Introduction of laser marking for Vishay Cera-Mite

Product Change Notification

Product Group: Vishay Ceramic Capacitors / March 12, 2014 / PCN-CC-001-2014 Rev 0

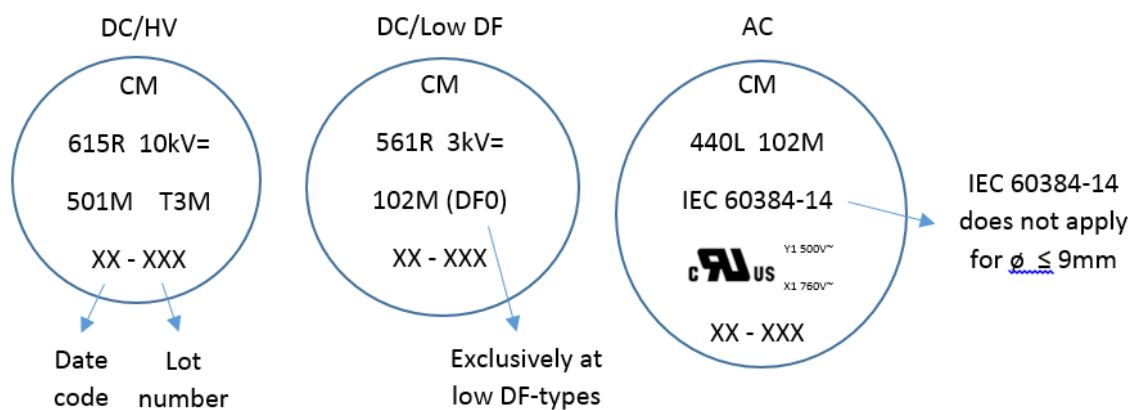
DESCRIPTION OF CHANGE: In line with our commitment for continuous improvement we additionally introduce laser marking along with a modified marking including date code and lot number for Vishay Cera-Mite components. Both marking technologies, existing tampon-print as well as new laser marking, will be used in parallel. The existing tampon-print marking will show neither a date-code nor a lot number. During introduction period, deliveries of affected products with mixed marking method are possible. The labeling will remain unchanged. There is no discontinuation of any components. The modified marking will be as follows:
